Office Action Summary	Application No. 10/624,524	Applicant(s) LEE ET AL.	
	Examiner Nhan T. Tran	Art Unit 2622

DETAILED ACTION

Claims 1-4, 6, 8-11, 14-28, 30-34 are rejected under 35 U.S.C. 102(e) as being anticipated by Wada (US 6,965,413).

Fig. 2B in Wada is used to illustrate the viewing directions and imaging directions of the camera phone.

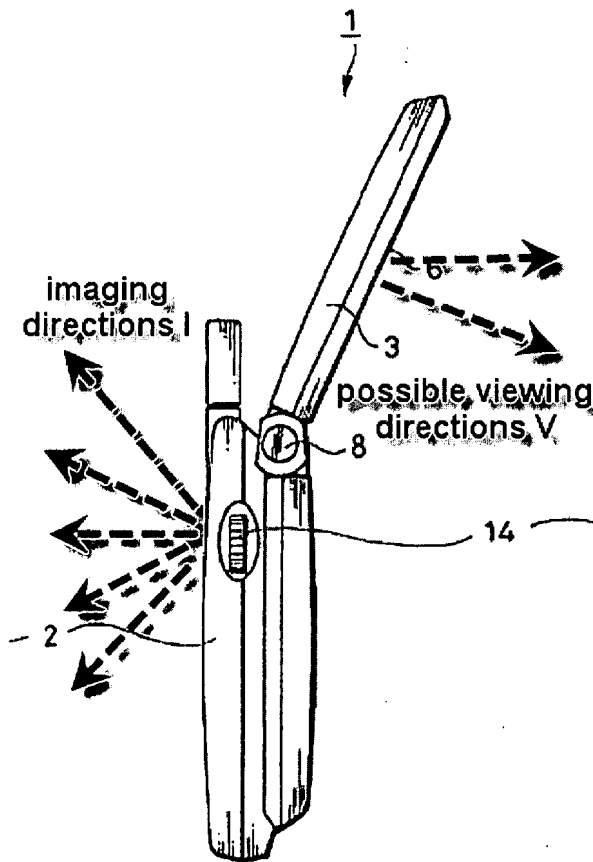
a camera module (11) mounted within a rear surface of the main body (2) and at an upper portion of the rear surface of the main body for imaging a target (see Fig. 2A and col. 2, line 51 – col. 3, line 16), wherein the camera module is mounted such that a viewing direction of the display and an imaging direction of the camera module are substantially parallel when the folder is in the opened state (see the illustration of Fig. 2B on next page for the possible viewing direction V and the imaging direction I that are parallel with each other. Note that the viewing direction is not always perpendicular to the display 6, it can be at a plurality of different angles depending on the user's position).

Regarding claim 2, as seen in the illustration of Fig. 2B above in claim 1, the disclosure of Wada also encompasses that the camera module is mounted at a predetermined angle such that the imaging direction (directions I which include a plurality of incident light directions by virtue of the field of view of the camera) forms an angle of approximately 90 degrees with respect to a rear surface of the folder when the folder is in the opened state.

Regarding claim 3, as seen in the illustration of Fig. 2B above in claim 1, the disclosure of Wada also encompasses that the camera module is mounted such that there is formed an angle of 30° between the imaging direction and a normal to the rear surface of the main body.

Regarding claim 16, as seen in the illustration of Fig. 2B above in claim 1, the disclosure of Wada also encompasses that the display viewing direction comprises a direction that is substantially orthogonal to a viewing surface of the display.

Regarding claim 17, as seen in the illustration of Fig. 2B above in claim 1, the disclosure of Wada also encompasses that the camera imaging direction comprises a direction that is substantially parallel to a bisector of a field of view of the camera.
